Docket: NRC-2012-0041
Issuance and Availability of Draft Regulatory Guide

Comment On: NRC-2012-0041-0002
Draft Regulatory Guide DG-1261 - Conducting Periodic Testing for Breakaway Oxidation Behavior

Fuel Reliability Program_FRP 2014-02

Subject: RIN 3150-AH42, "Performance-Based Emergency Core Cooling Systems Cladding Acceptance Criteria"

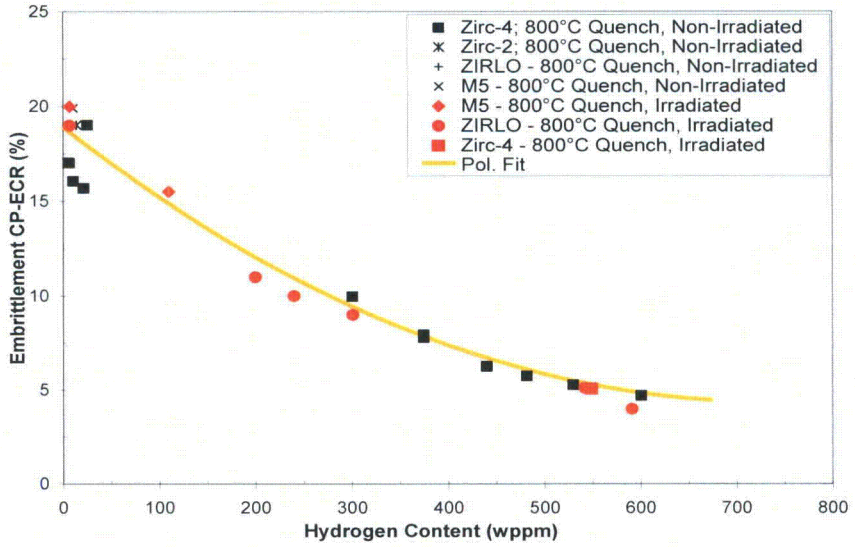
Comment	Use of test specimens with hydrogen pre-charge can provide a suitable surrogate for irradiated materials, obviating the need for the hydrogen concentration to be within 50 ppm of irradiated data. Moreover, if testing of irradiated cladding for significant compositional changes is elected, testing to compare hydrogen pre-charge data can be reduced to one irradiation exposure near end-of-life condition.
Rationale	The NRC test results plotted below showed no difference in behavior between irradiated and non-irradiated materials for multiple alloys made by different fuel vendors. The test data support the use of hydrogen pre-charge as a surrogate for irradiation.

Numerous mechanical tests have shown irradiation damages are annealed out at LOCA temperatures (> 700°C). Irradiation will have a small impact on the chemical makeup of zirconium based alloys, which are typically greater than 97% zirconium. A very small fraction of the alloying elements may transmutate into other elements. Testing of different irradiated alloys in the ANL program showed transmutation of the common alloying elements in commercial service today to have no effect on the cladding ductility degradation and therefore additional testing of irradiated cladding of variations of these alloys is not needed. If the alloy composition changes significantly, such as the addition of new alloying elements, the transmutation effect could still be captured by the addition of expected transmutation products (non radioactive isotope) into the alloy melt for evaluation.
